Informal meeting on Code of Practice for Packing of Cargo Transport Units

Geneva and virtual, 17-18 March 2022

Liquids in flexitanks

Submitted by ETS Consulting

Figure 19 - Flexitank Transport Process – Cargo

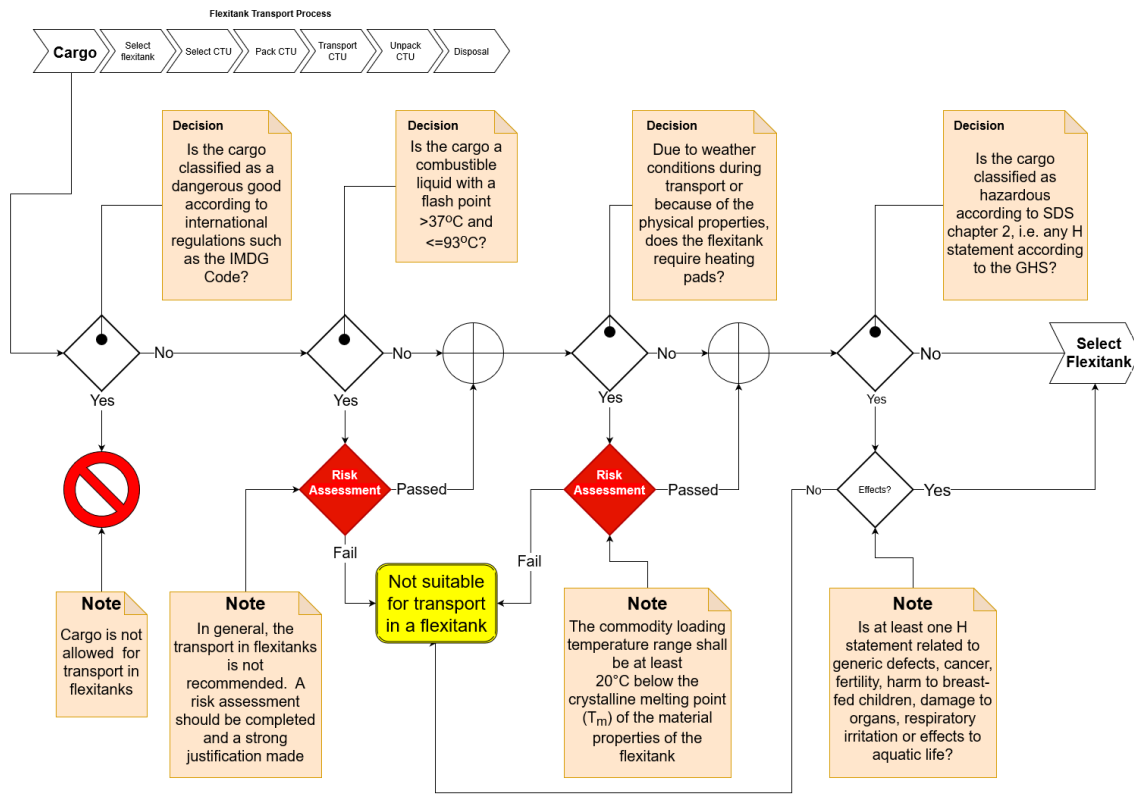
5.2.6.1 Commodity considerations

The process chart shown in Figure 9 should be followed to understand whether a commodity is suitable for transport in flexitank:

Figure 10 – Flexitank transport Process - Flexitank selection

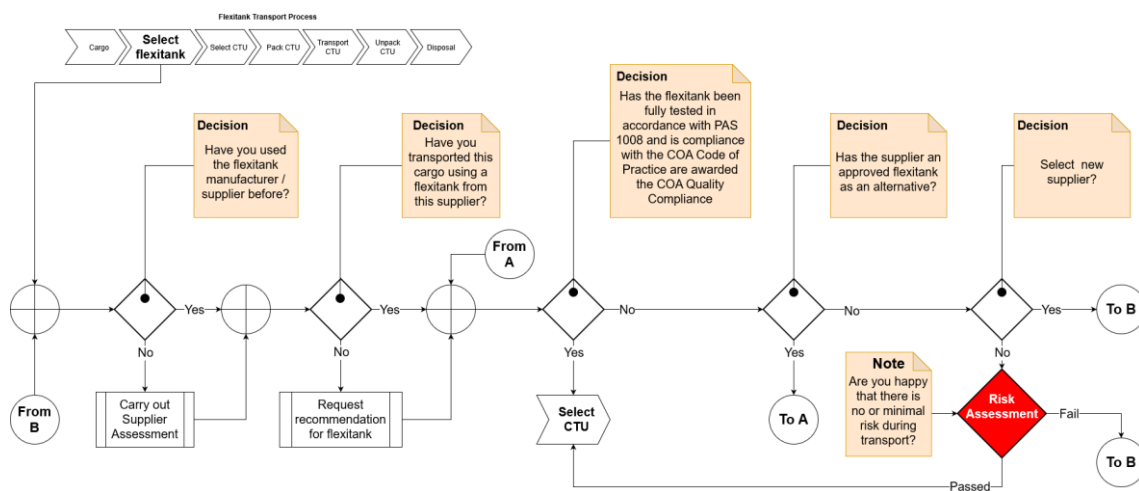
Consignors and shippers should follow the process shown in Figure 10 to:

- select a flexitank manufacturer who has had their flexitank tested, certified and listed in the Container Owners Association (COA) Flexitank Quality Management List (FQML) with the status COA Member Certificate of Compliance.
- operate the flexitank system in accordance with the manufacturer’s instructions and best practice to ensure safe and reliable outcome.
- carry out appropriate risk assessments of the flexitank system and the cargo to ensure safe and reliable processes.
- transport only cargoes that are classified as non-regulated (non-dangerous) and are compatible with the flexitank system.

Figure 244 – Flexitank transport process - CTU Selection

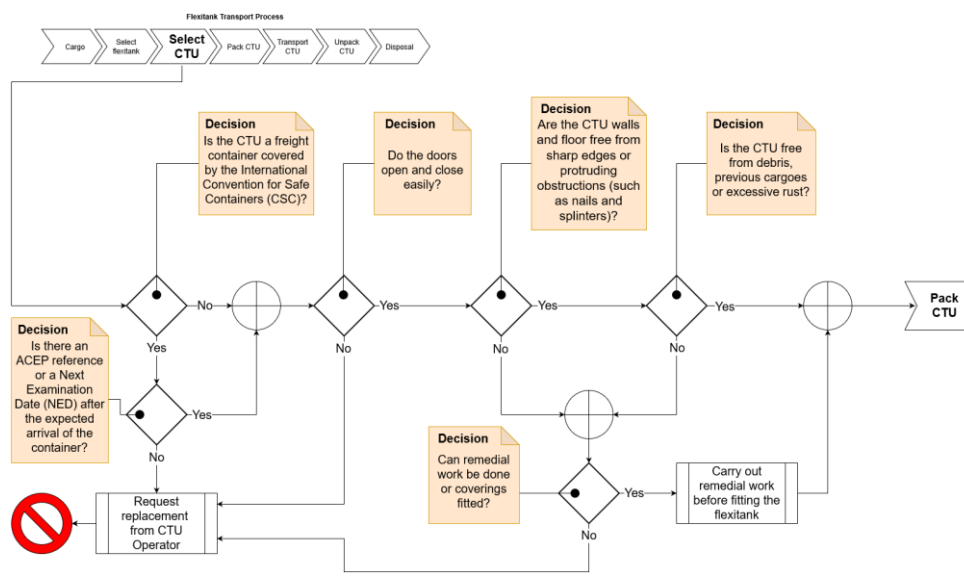
CTUs for the carriage of flexitanks must be in good serviceable condition and fit for purpose and Figure 11 follows the CTU selection and approval process..

Figure 342 - Flexitank transport process – Packing

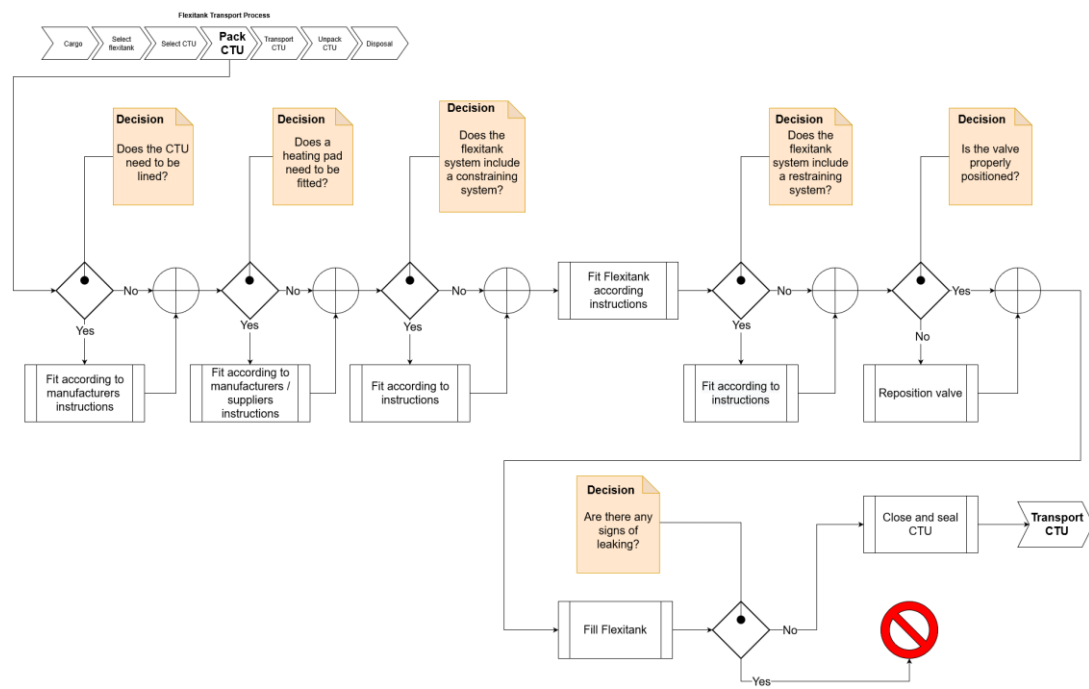
Figure 12 follows the fitting and packing process.

Figure 514 - Positioning flexitanks

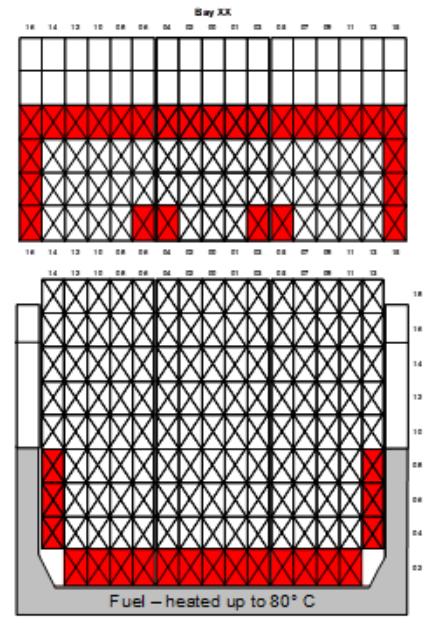
- Temperature sensitive cargoes should not be placed on or near heated bunker tanks, the elevated temperature required to keep the fuel viscosity low may heat or otherwise damage the cargo (red slots below deck in Figure 14). Note the height up the side will depend on the ship's design and may be higher or lower than shown in the figure. Containers carrying flexitanks should not be stowed adjacent to the engine room bulkhead.

- Above deck, containers with flexitanks should not be stowed in the outer and upper most slots as or at the edges of deck covers (red slots above deck in Figure 5Figure 14) as.
